Addendum 3
July 2, 2024
South Jersey Port Corporation (SJPC)
Request for Proposals
RFQ # SJPC-24-42 Construction of Rail Track Extension At Broadway Marine Terminal
NOTICE

This Addendum is considered part of this Request for Proposals and must be acknowledged with your submission.
ANSWERS TO FORMALLY SUBMITTED QUESTIONS

Existing Inlets in Project Area

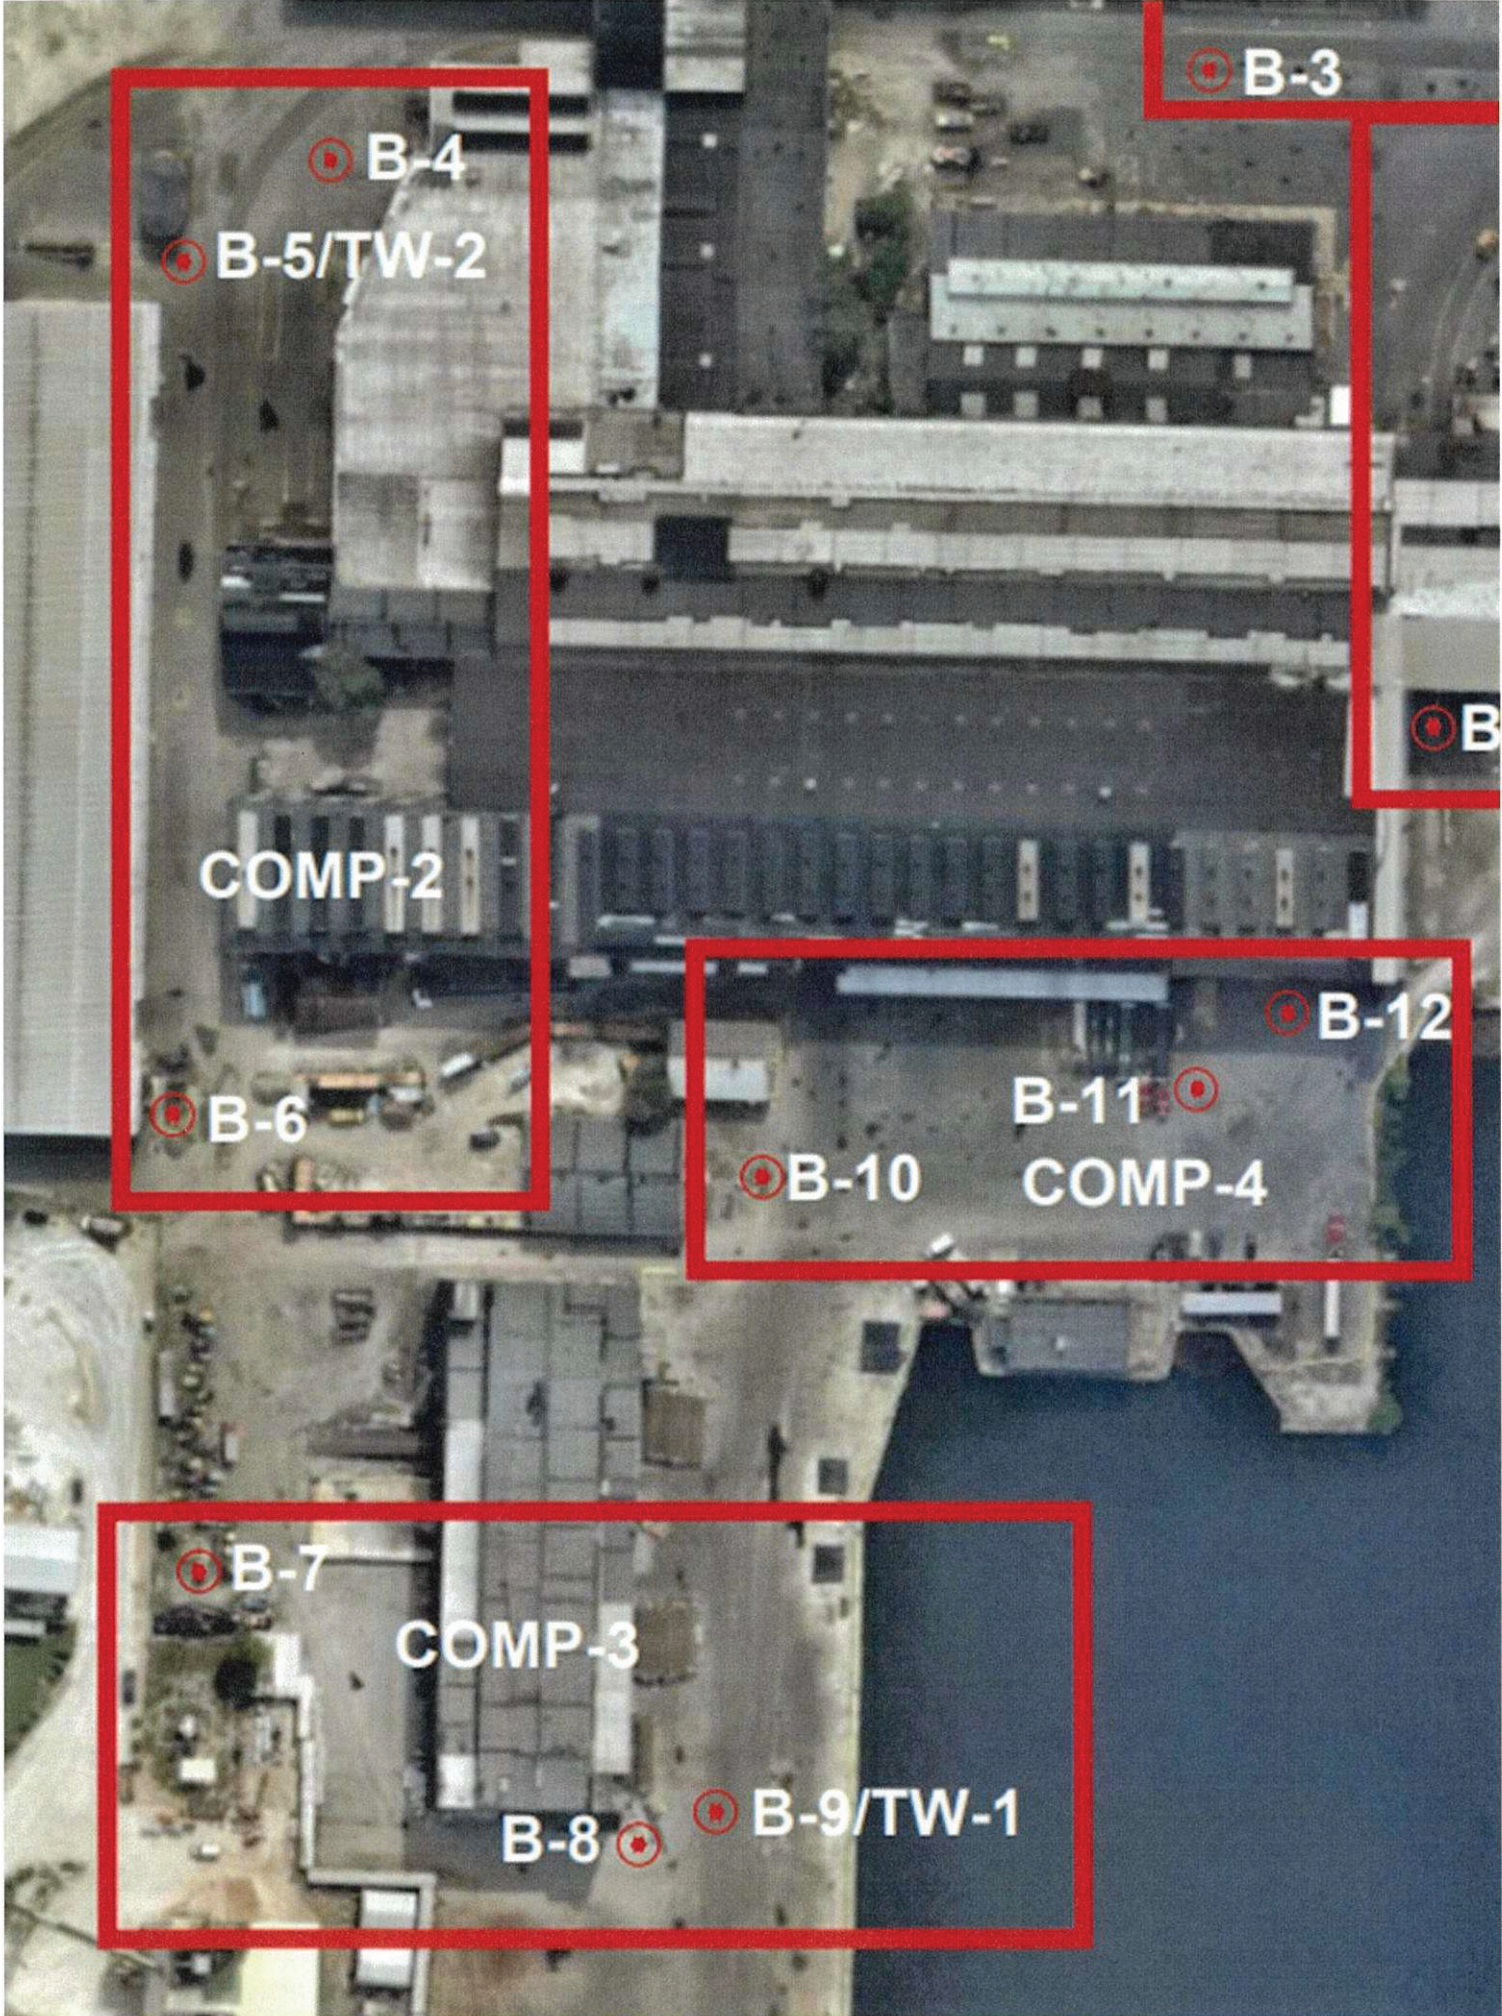
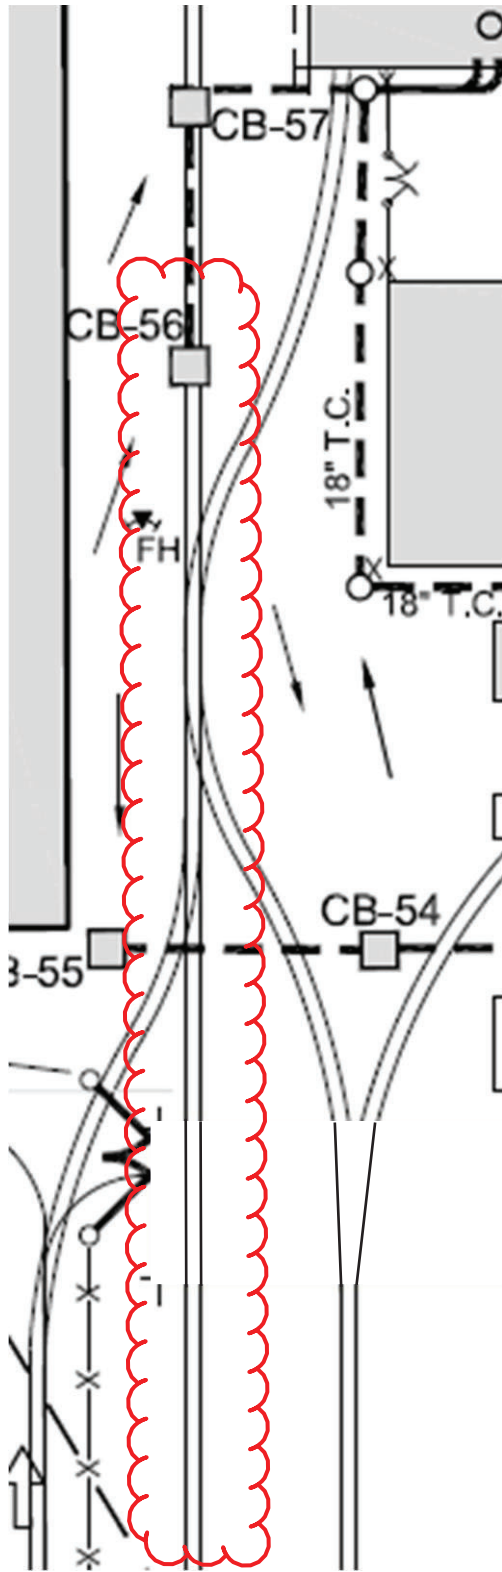
- Task 2 requires the asphalt be sloped to existing inlets. Please identify in a plan or map which inlets, and also please specify the overall asphalt limits for removal/paving so all bids can be comparative.

- Response: See the attached sketch showing the location of existing inlets. The new paving should extend to both sides a minimum of 15 feet from the centerline of the rail.
